## SERVICE BULLETIN

TS-940S LCD CLOCK DISPLAY ERRATIC OPERATION

TS-940S PLL UNLOCK

TS-940S AGC CIRCUIT IMPROVEMENTS

▲ Component side view.

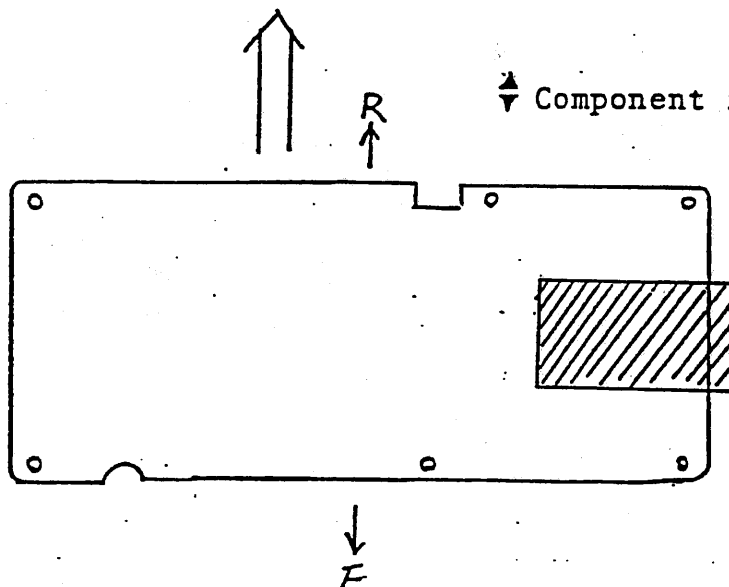
R304: 5.6K ohm 1/6 W Resistor.....RD14BB2C562J

1. Add the circuit as shown below.
2. After the circuit has been installed adjust VR4 for a 10-15 watt output when the antenna tuner operates.

\* Mounted on foil side.

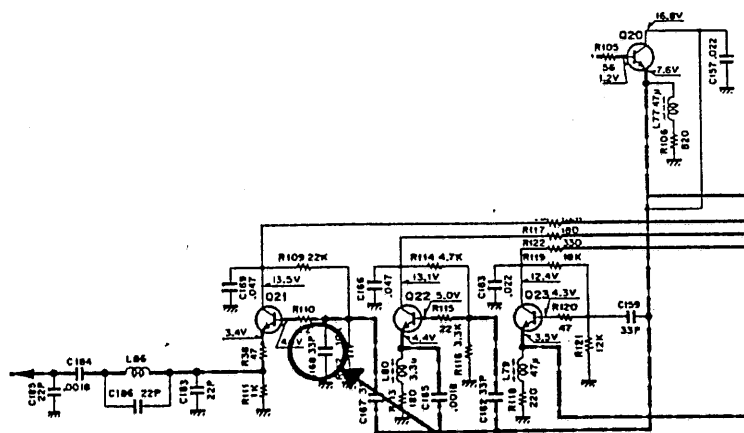
Reports of a PLL Unlock on the lower frequencies may be due to low VCO levels. The following change will increase the VCO level and should prevent reoccurrence of this symptom.

C168.....change to 15 pF 50 v (CC45SL1H150J)

1. On the RF Unit (X44-1660-00) change C168 from a 33 pF capacitor to a 15 pF 50 v capacitor.
2. Readjust the VCO BPF (RF unit L74-76) according to the instructions contained in the TS-940S service manual.

AVR UNIT (X43-1500-00) Component side view

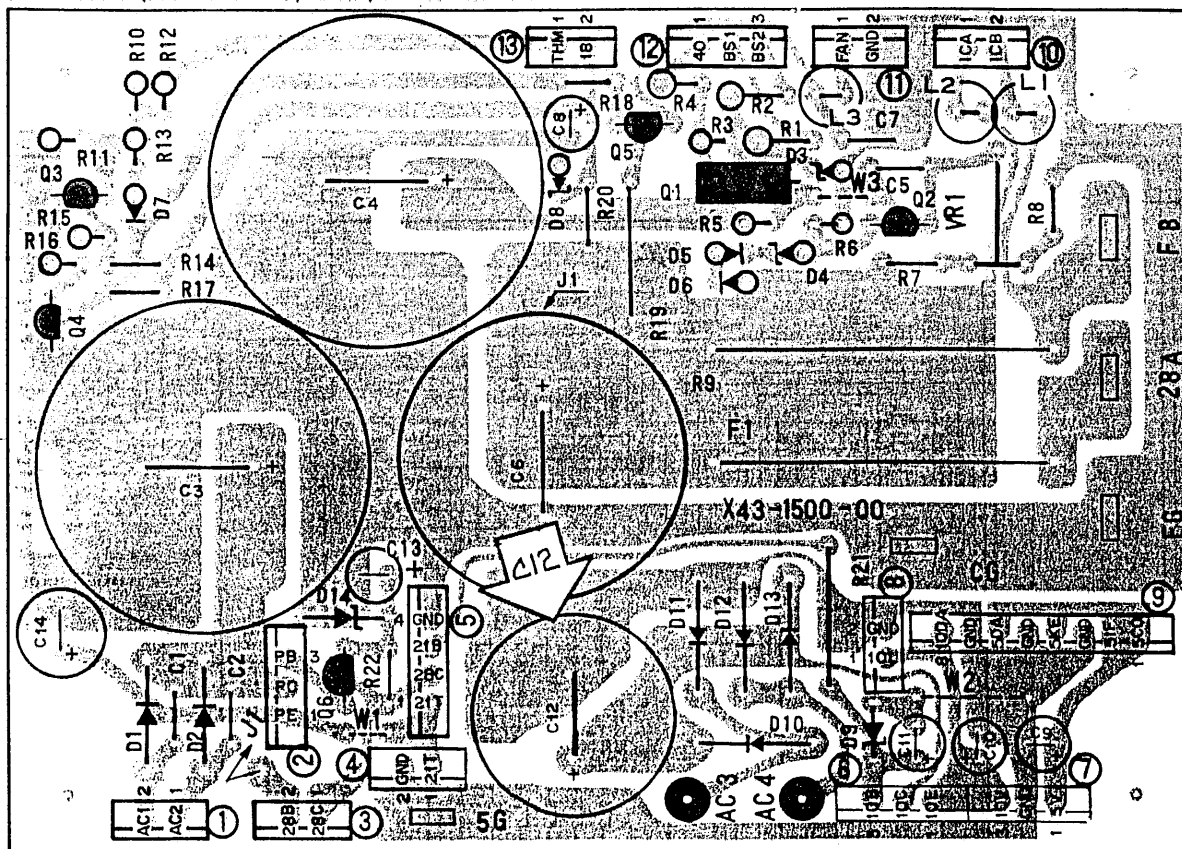
In those areas of the country that are subject to large power line voltage fluctuations, excessive voltage may be applied to capacitor C12 on the AVR Unit (X43-1500-00). These voltage fluctuations might exceed the capacitor breakdown voltage. Replacing capacitor C12 with a capacitor having a higher breakdown voltage will help prevent this potential problem.

On the AVR Unit (X43-1500-00) change C12 from a 6800  $\mu$ F capacitor to a 5600  $\mu$ F 25 v capacitor (C90-2037-05).

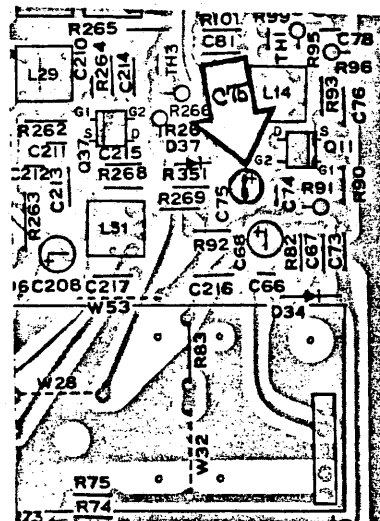
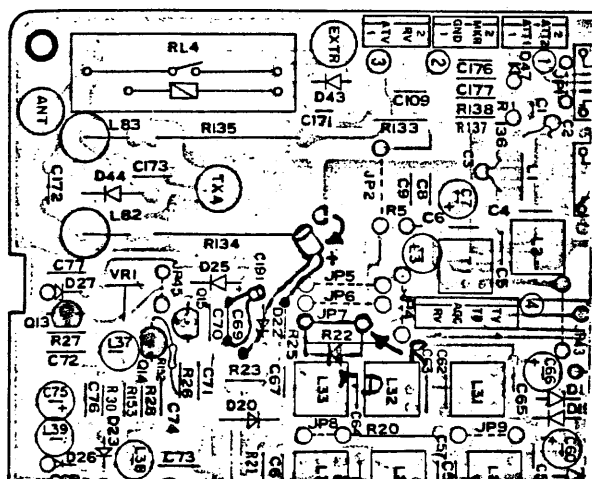
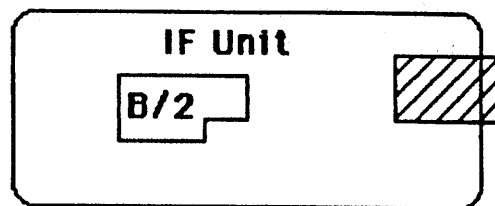
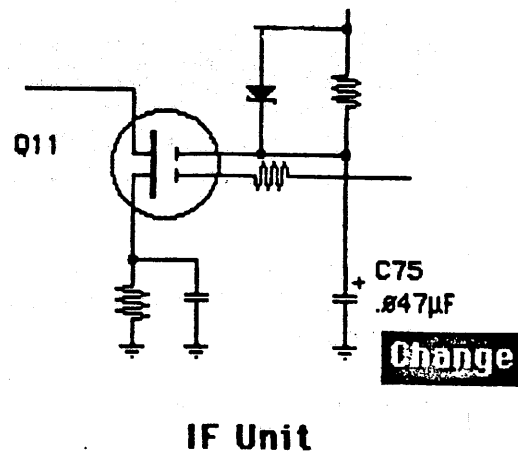
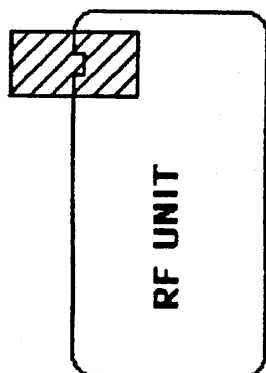
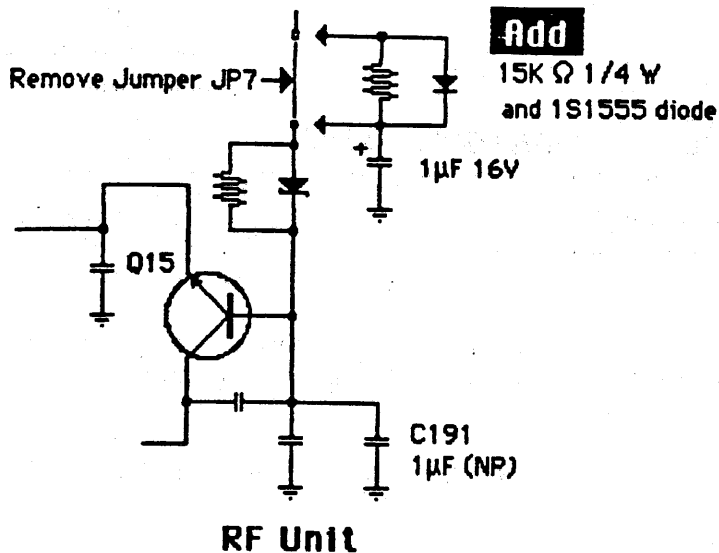
1. Remove jumper wire JP7 and replace it with the parallel combination of the 15 k ohm resistor and the 1S1555 diode. Pay close attention to polarity.
2. Add the 1 uF capacitor as shown in the diagram.

Change capacitor C75 from a 1 uF 50 v capacitor to a .047 uF 50v capacitor.

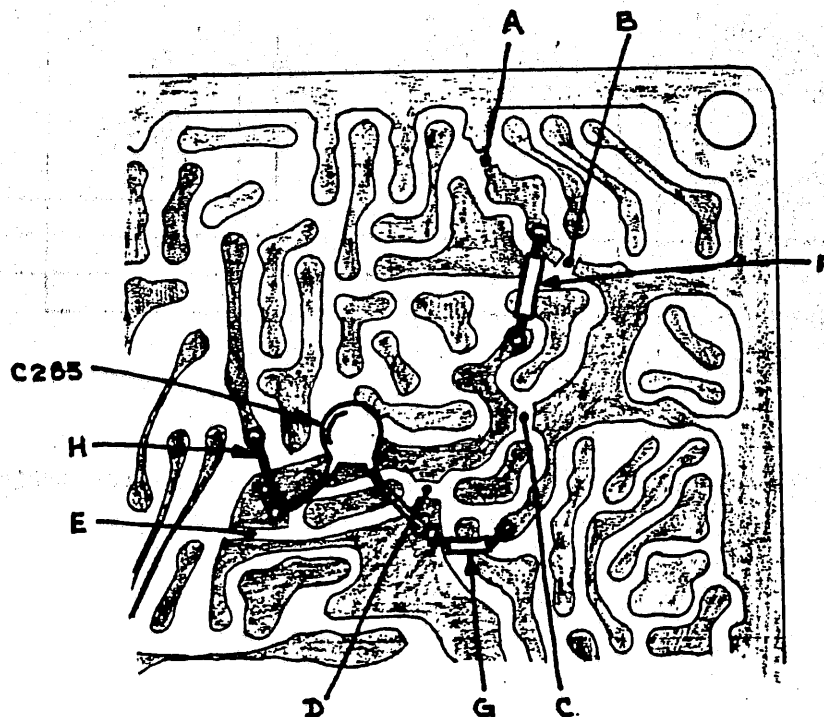
- Cut the foil patterns labeled A-E in figure 1.
- Add the jumpers wires labeled F-H in figure 1.
- Add capacitor C285 .01 uF 50 v as shown.

# IF UNIT (X48-1430-00)

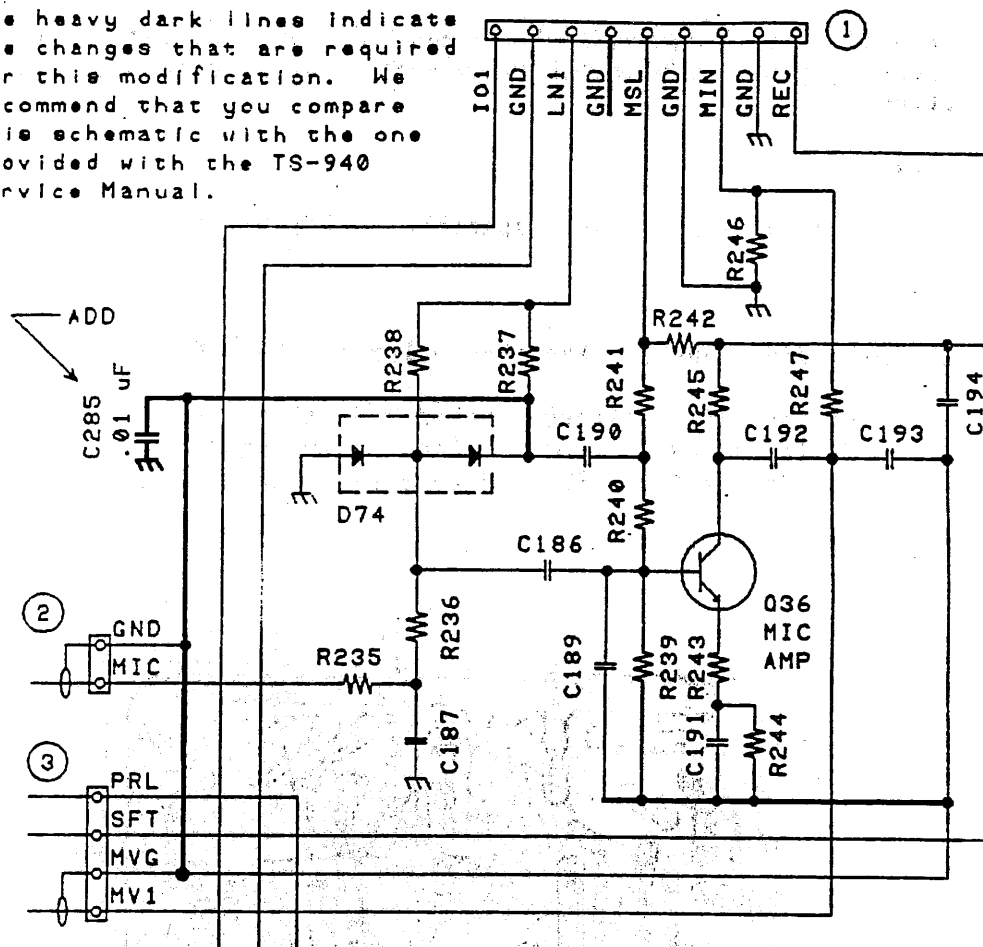
The heavy dark lines indicate the changes that are required for this modification. We recommend that you compare this schematic with the one provided with the TS-940 Service Manual.

IF Unit (X48-1430-00)  
Foil Side

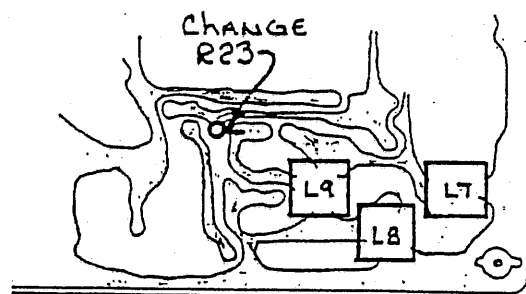
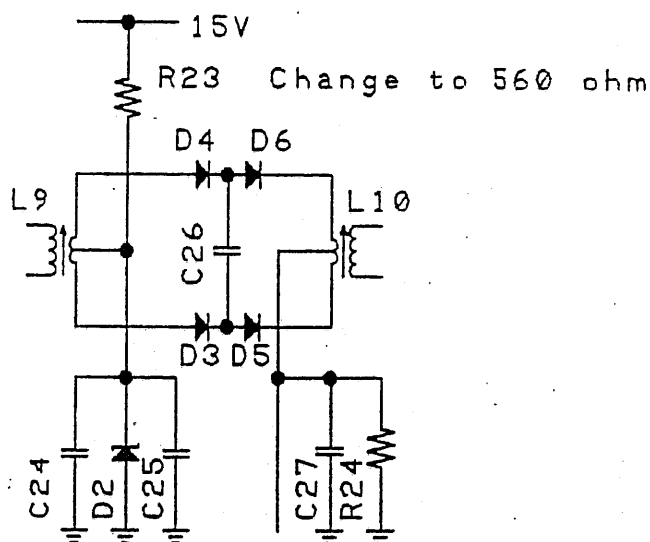
The following change will reduce the tendency of the Zener Diode in the Noise Blanker circuit to cause an increase in the ambient noise level. This change ensures that no current flows thru this diode in the normal receive position.

On the IF UNIT (X48-1430-00) change R23 from 330 ohms to 560 ohms.

PLL Unit (X50-2020-20)

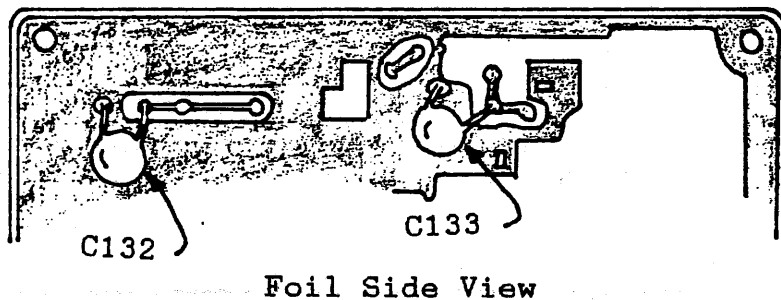
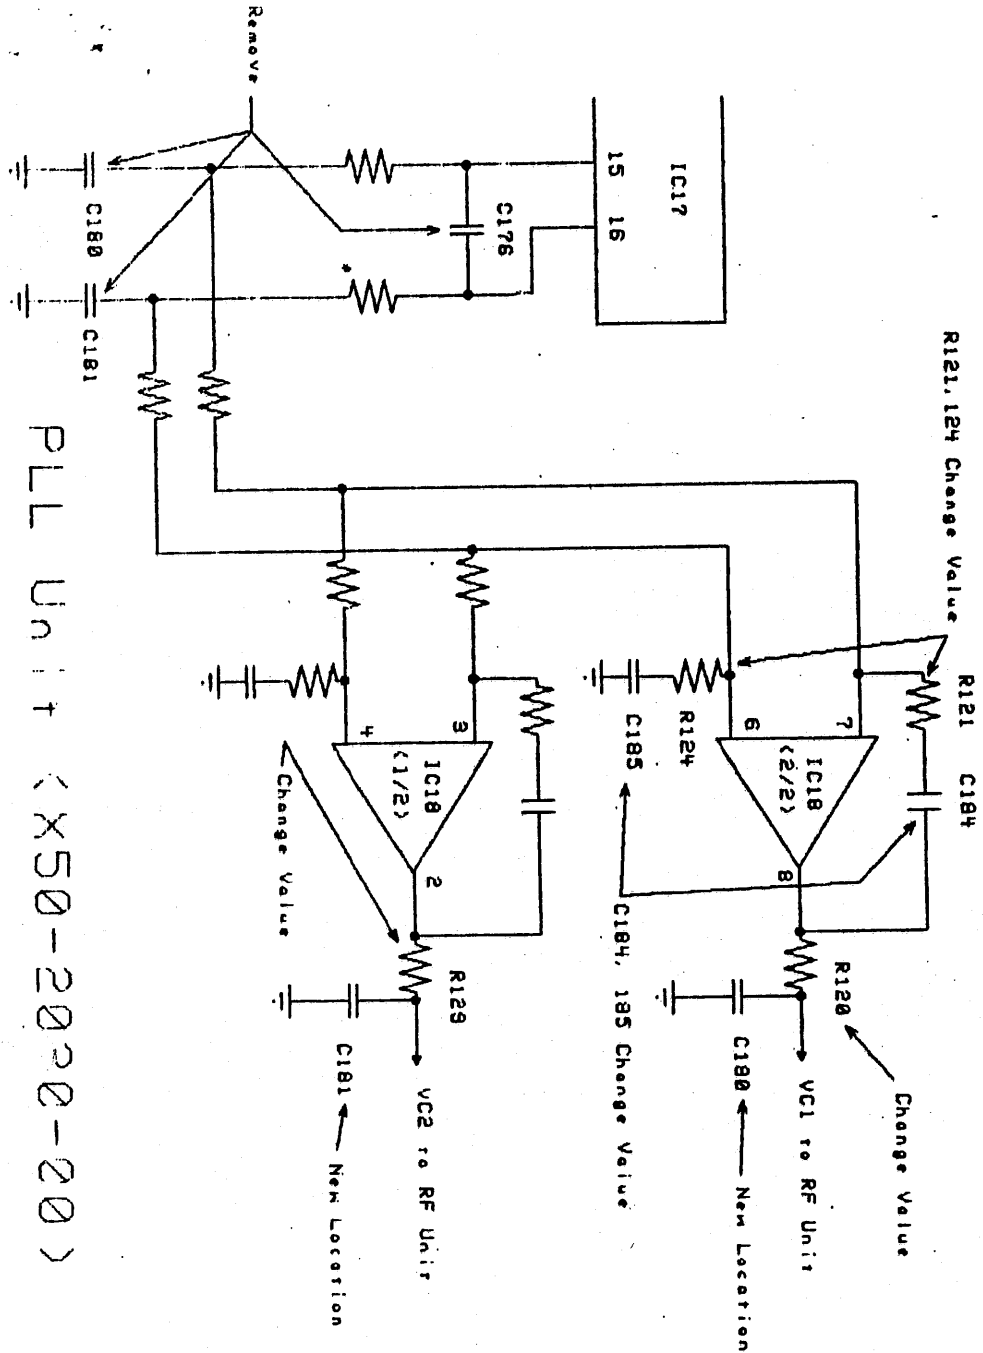
On the PLL UNIT (X50-2020-00) remove capacitors C176, C180, and C181. Change resistors R120 and R129 from 470 ohms to 3.3 K ohms. Change resistors R121 and R124 from 1 K ohm to 680 ohms. Change capacitors C184 and C185 from .22 uF to .33 uF 35V tantalum capacitors. Install C180 and C181 in the positions shown in the accompanying diagrams. The use of new capacitors is recommended to improve reliability, don't try to reuse the old capacitors! Capacitors C181 and C180 should be attached to the foil side of the PLL unit.

RF Unit (X4+-1560 00)

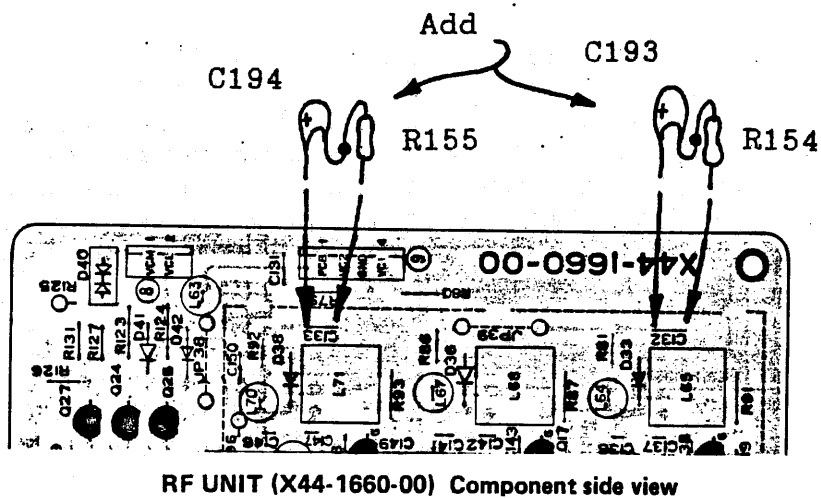
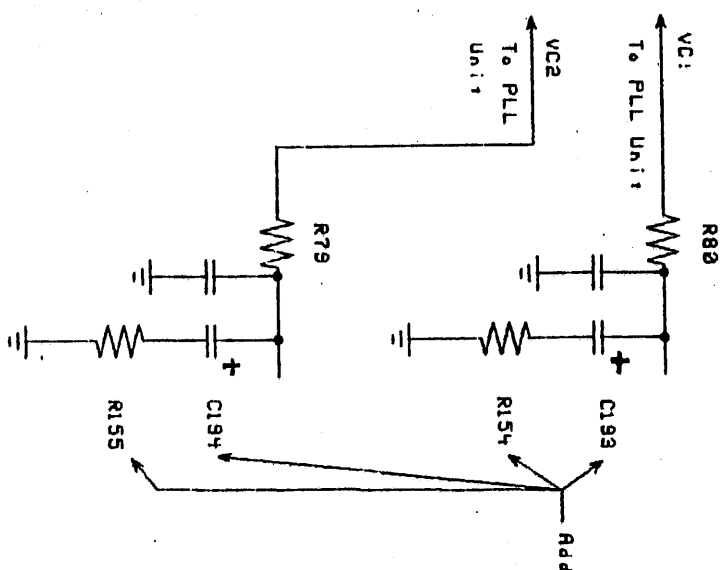
On the RF Unit (X44-1660-00) install the series RC circuits composed of R154 and C193, and R155 and C194, as shown in the accompanying diagrams. As the diagrams illustrate it is easiest to move C132 and C133 to the foil side of the board and install the series RC circuits on the component side.

FIGURE 1

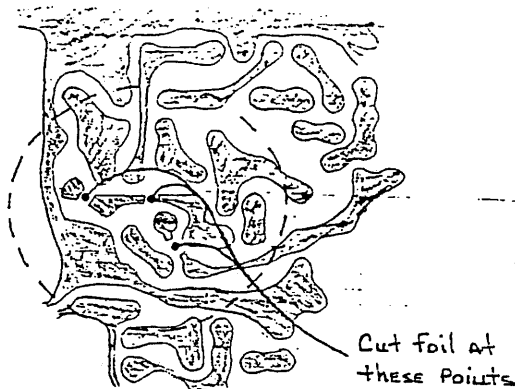
8. Using a small craft knife, cut the foil at the 3 points shown in figure 1 (top right corner of the board).
9. Unsolder and discard resistors R194 and R197. They are mounted on the component side of the board and soldered on the foil side.

FIGURE 3

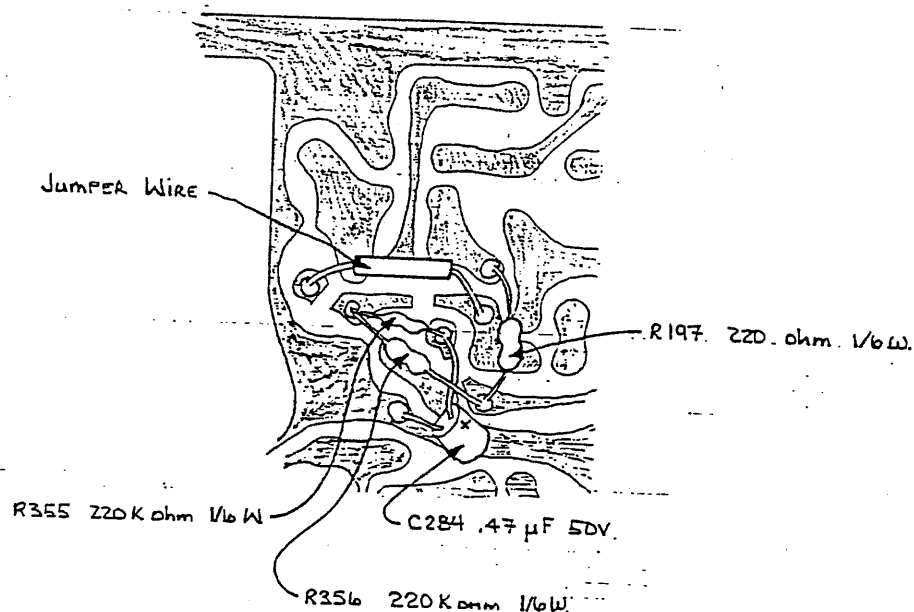
11. On the foil side of the board, add the 3 resistors (R197, 355, 356) as shown in figure 3.
12. Add a small jumper wire as shown in figure 3.
13. Add capacitor C282 as shown in figure 3. Observe polarity and insulate the positive (+) lead with shrink tubing.
14. Carefully place the board in its original position (do not pinch wires) and secure it with the 7 screws.
15. Plug in connector # 17. Move the 4 wires on the far side of the board back to their original position.
16. Put the covers back on the TS-940S and secure them with the 16 case screws.
17. Connect the antenna and power cord then test the transceiver for normal operation.

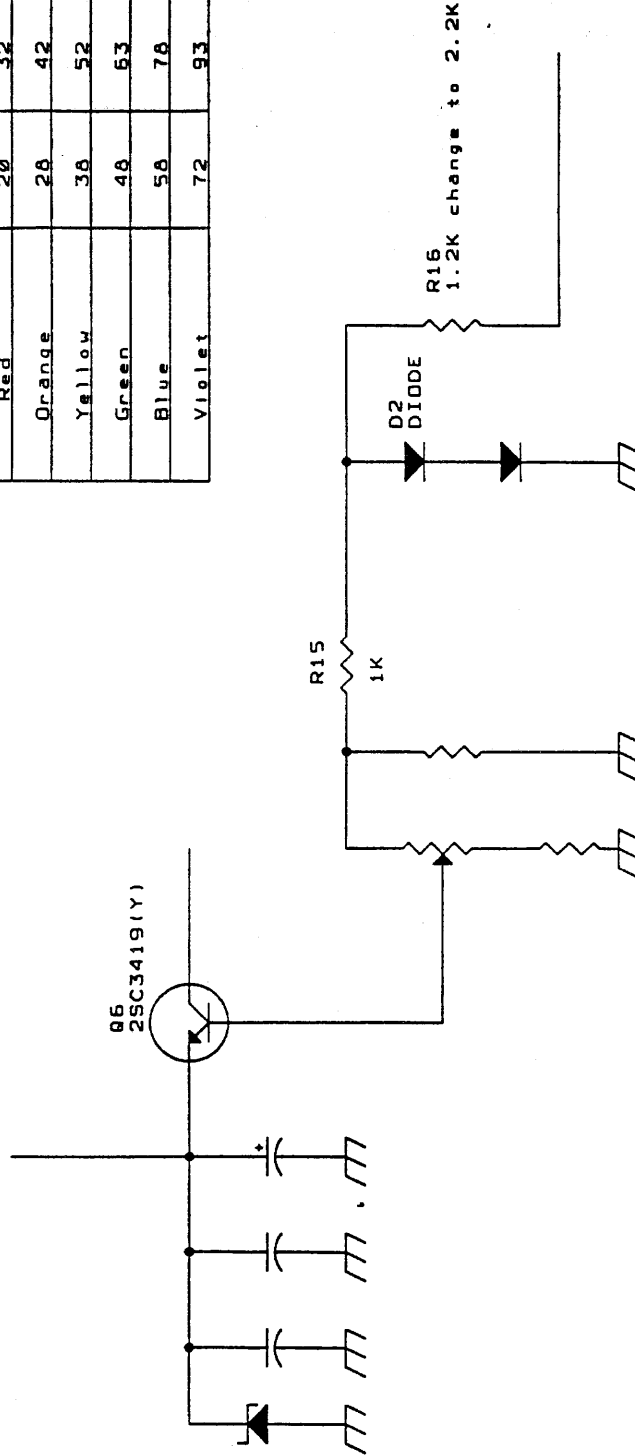
Use of Red, Orange, or Yellow hfe color rankings is recommend. These lower gain transistors work just fine and do not suffer from the circuit instability problem. If you are only able to obtain the higher gain transistors you will need to modify the varistor/temperature compensation circuit on the final unit (X45-1400-00) by changing R16 from 1.2K to 2.2K ohms.

During its production the TS-940S used two different varistor values. The original part was an STV3H (O). It was changed in mid-production to an SV-03YS. R15 was changed from an 820 ohm resistor to a 1K ohm resistor at the same time. Therefore the countermeasure differs depending upon the serial number of the radio.
